IC1 W4025S

株式会社 WACOM CO., LTD
 名称 MOUSE

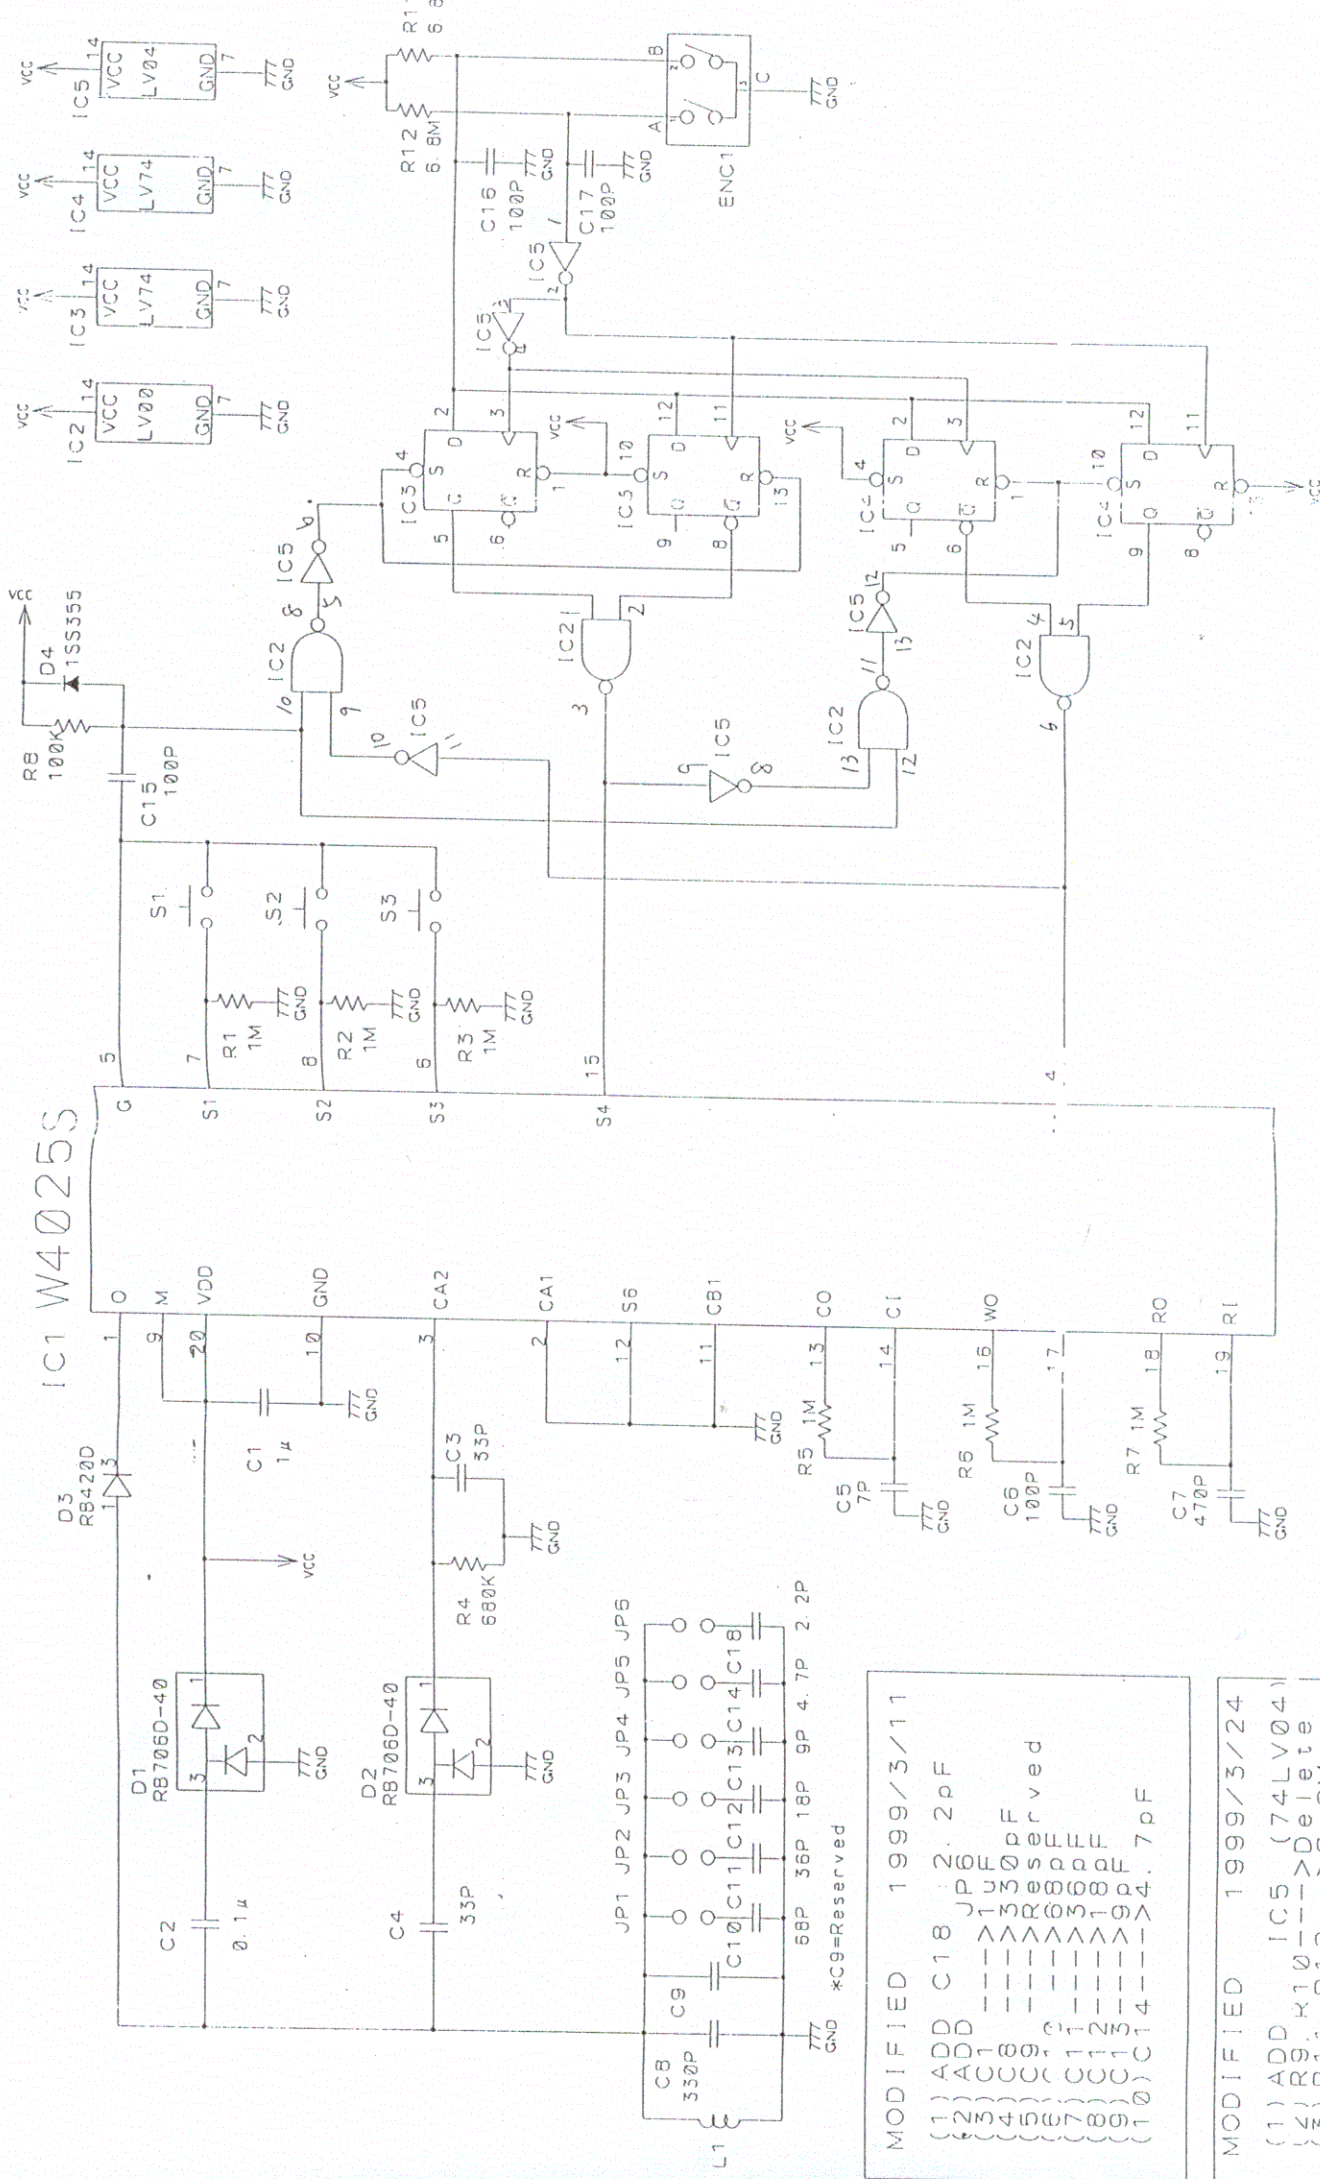
MODIFIED 1999/3/11
 (1) ADD C18 2.2pF
 (2) AC18 JPE
 (3) CC8 330pF
 (4) CC9 Reserved
 (5) CC10 500pF
 (6) CC11 500pF
 (7) CC12 500pF
 (8) CC13 500pF
 (9) CC14 500pF
 (10) C14 4.7pF

MODIFIED 1999/3/24
 (1) ADD IC5 (74LV04)
 (2) R9, K10 --> Delete
 (3) R11, R12 --> 6.8M
 (4) C16, C17 --> 100pF
